Access Compliance Report Public Rights-of-Way (Curb Ramps)

Main Street: MIDWAY_PL Cross Street: ADAMS_ST Location: W

ADA ID: RPRK210929160635 Ramp Type: Type 1 - Perpendicular Diagonal Initial Pass/Fail: Fail Overall Compliance: No Severity Score: 2

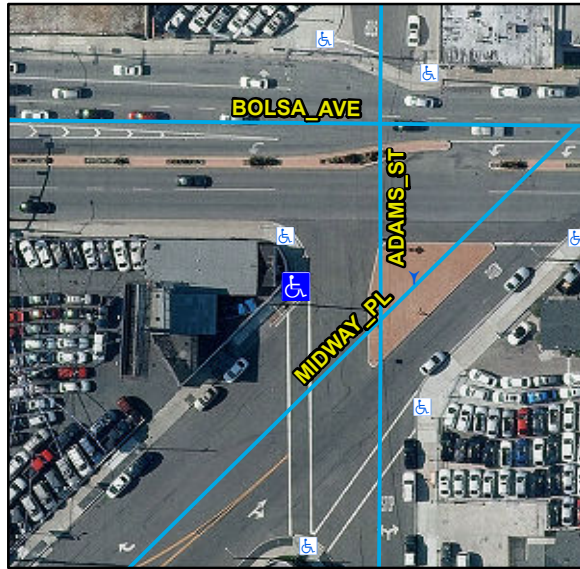
R304.2.2, R304.5.3, STD 1115

Remove & Replace Curb Ramp With Two New Directional Ramps or Equivalent.
